Troy School District

**RFP #2425-09 - Addendum #1
BP#2B High School Athletics - Phase #2
January 21st, 2025**

Troy Schools District – RFP #2425-09 BP#2B High School Athletics Renovations - Phase #2

Addendum #1 Bidder Clarifications

PROPOSED BUILDING SANITARY SEWER PROFILE

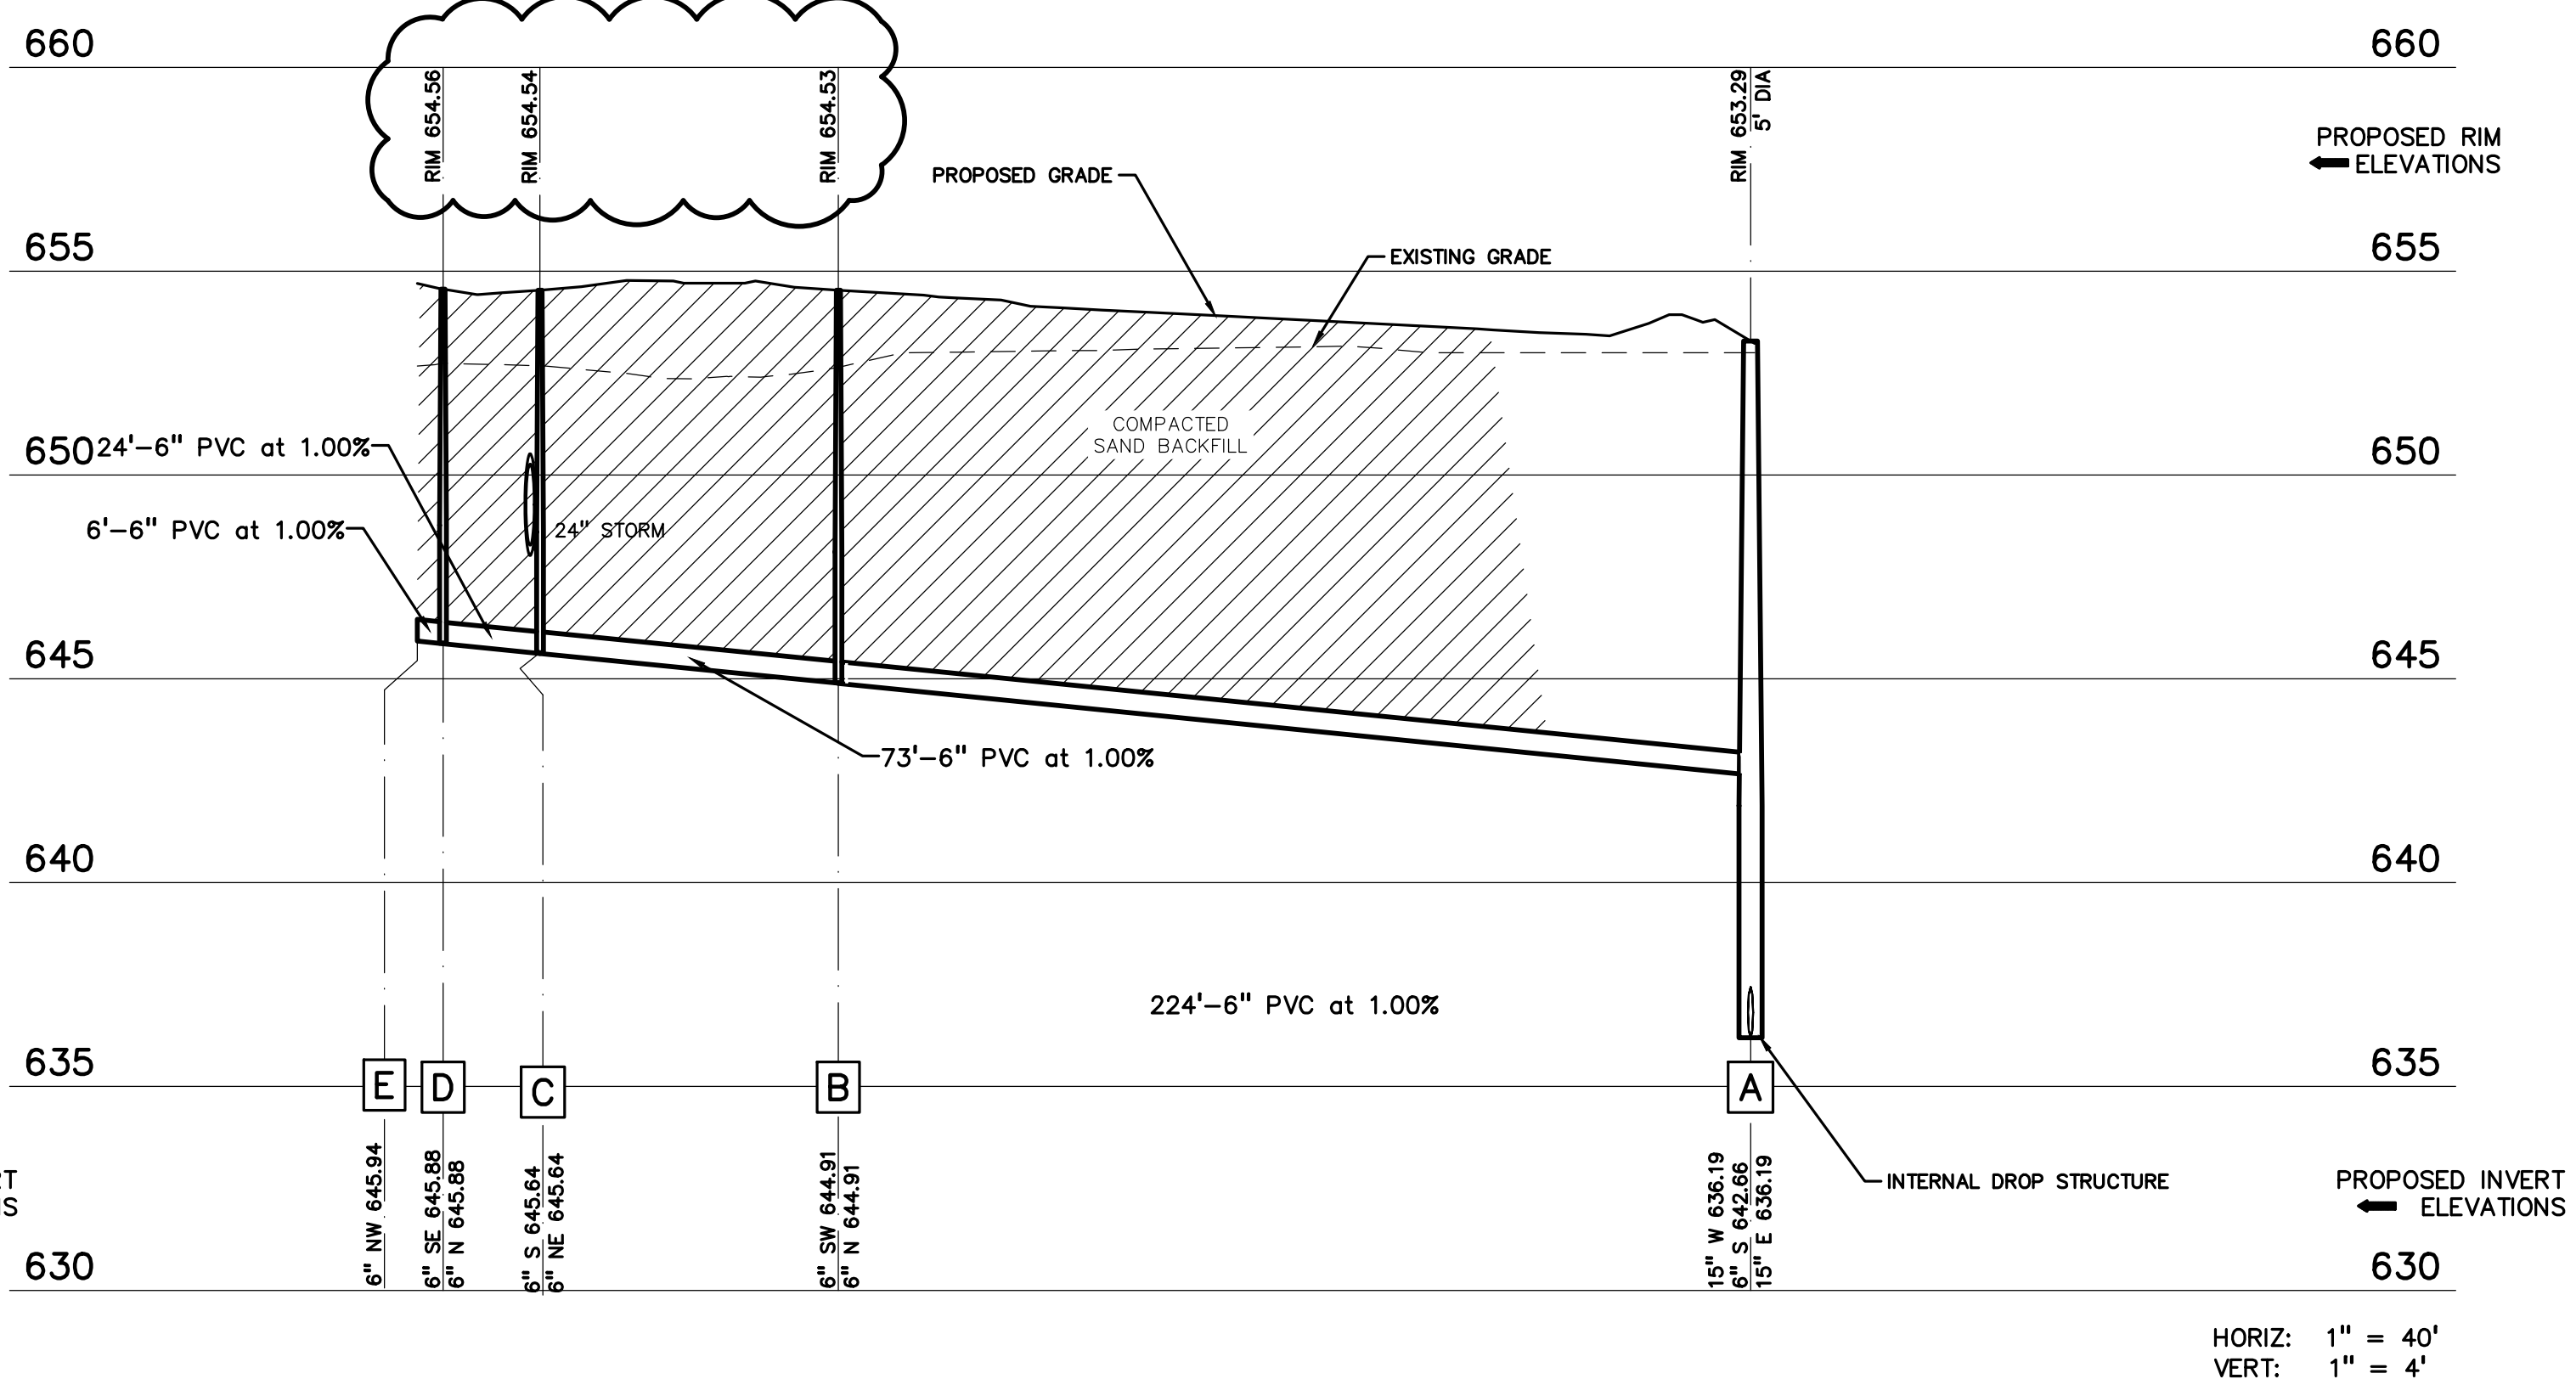
CD-10 Refer to Drawing No. C7.0 (reissued):
 A. Revised profiles to account for plan adjustments as indicated.

C-7.1

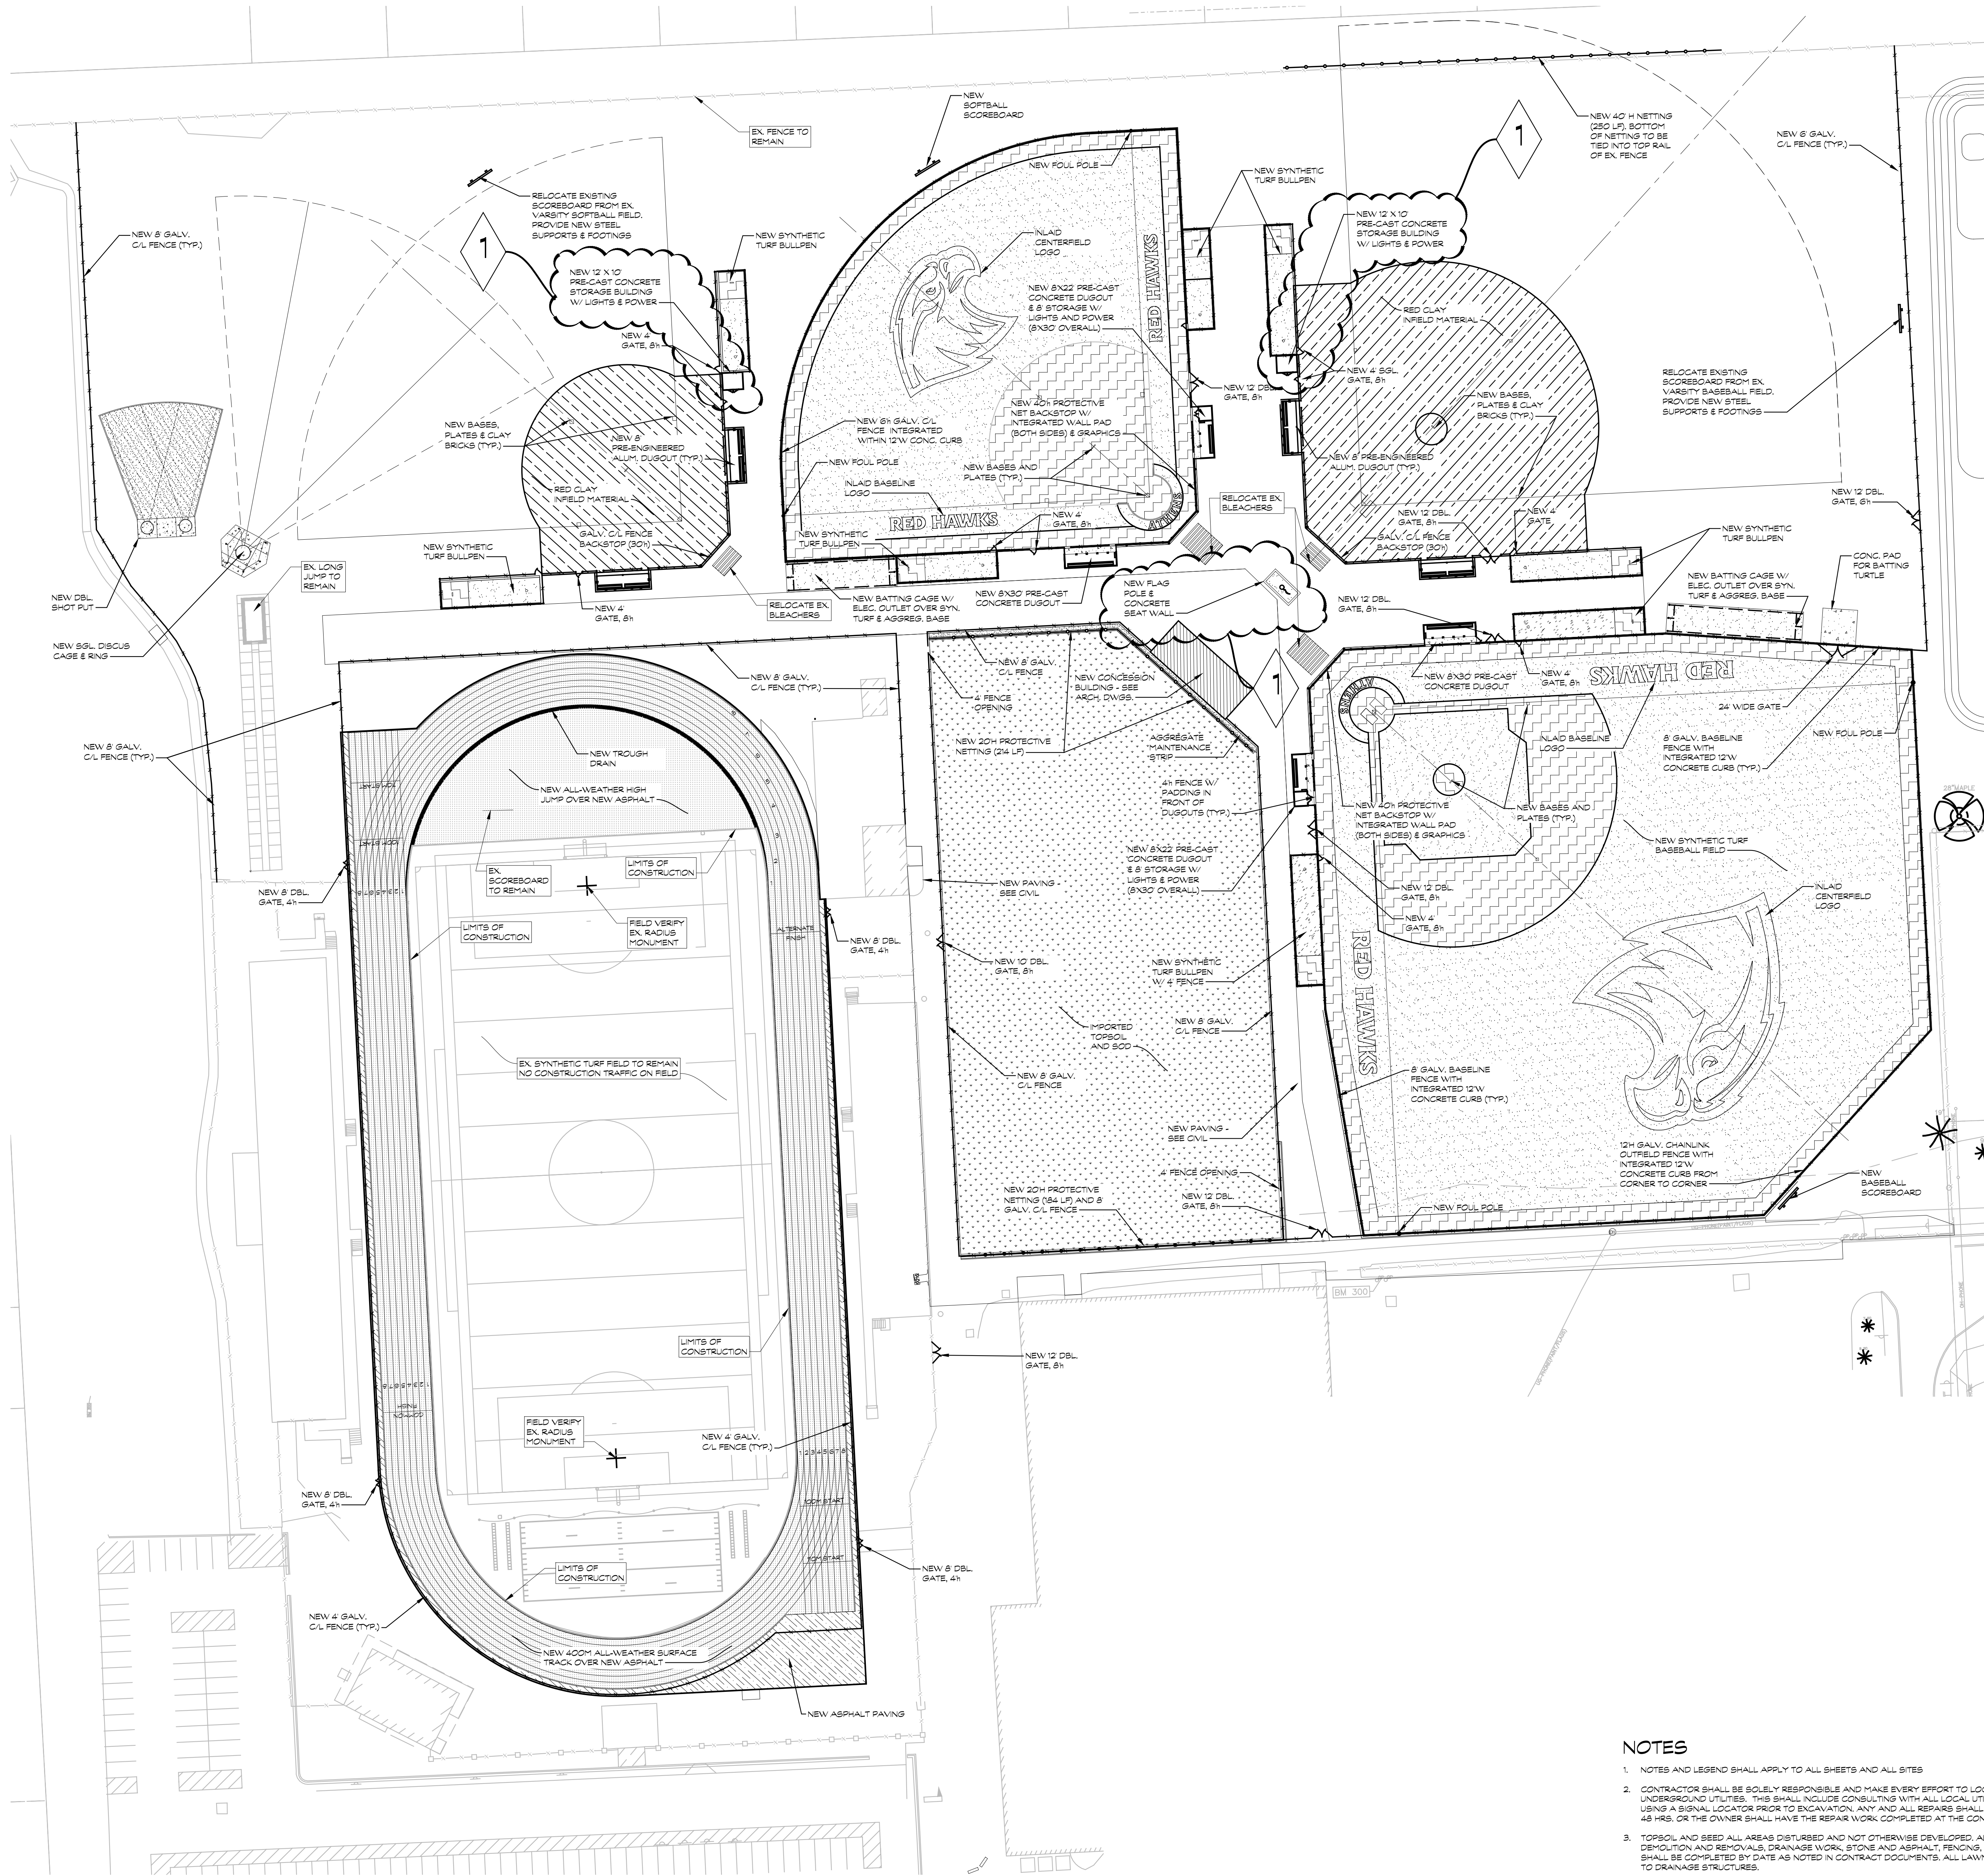
CD-11 Refer to Drawing No. C7.1 (reissued):
 A. Revised rim elevation labels for clean outs as indicated.
